## Product Change Notification

### PCN-ICC-1921-2018

| Business Unit            | Product Line Code | Type of Change              | Action                        | Date of Issue |
|--------------------------|-------------------|-----------------------------|-------------------------------|---------------|
| ICC - Industrial Cabinet | BE2               | Product Change Notification | Notify Distributors and Field | 7/12/2018     |

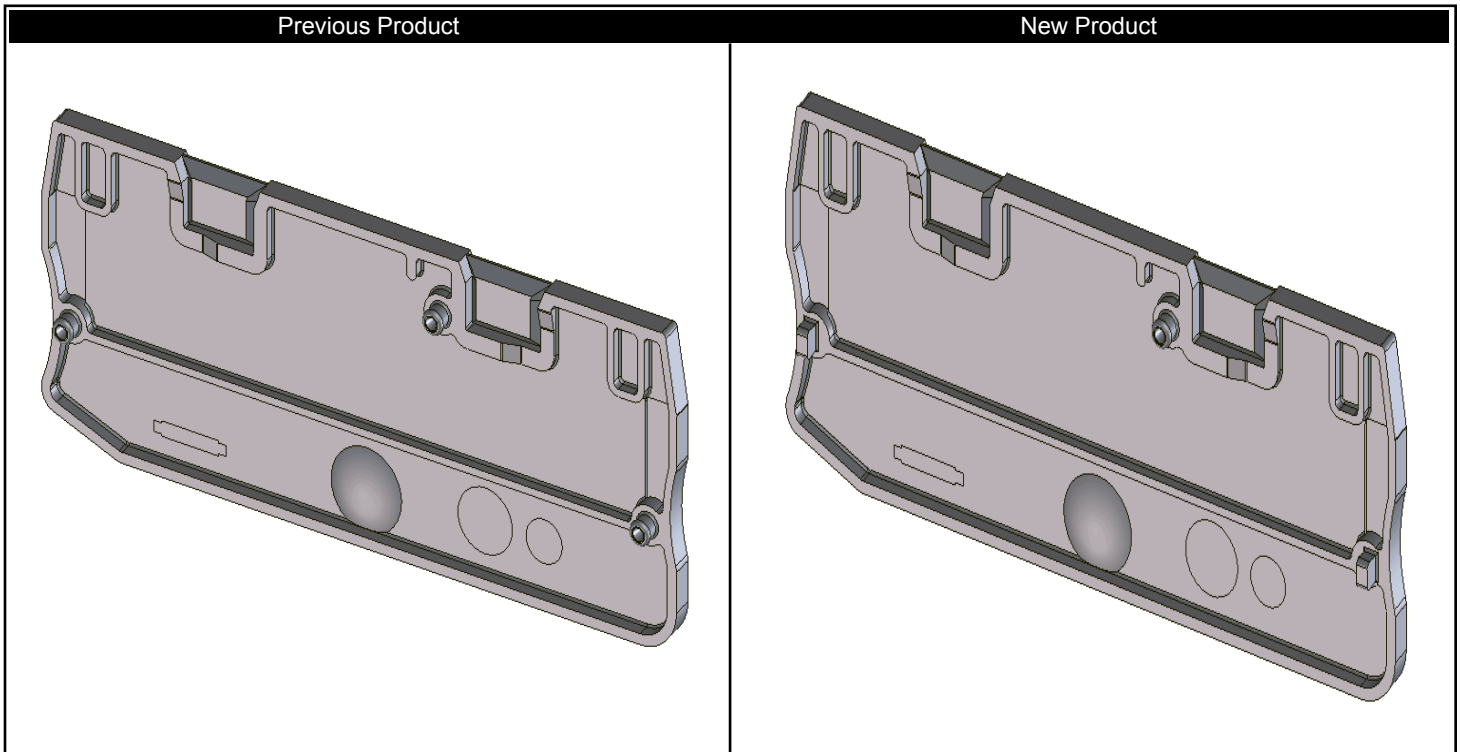
In consideration to a continuous improvement process of Phoenix Contact Push-in terminal blocks, there will be a change that effects the design of the covers mentioned below.

The change effects the snapping pin of the covers which are changed slightly to achieve an improved fitting. Therefore some pins are changed from round to rectangular. This change has no influence to the compatibility or the electrical performance of the products. Old and new shape are interchangeable.
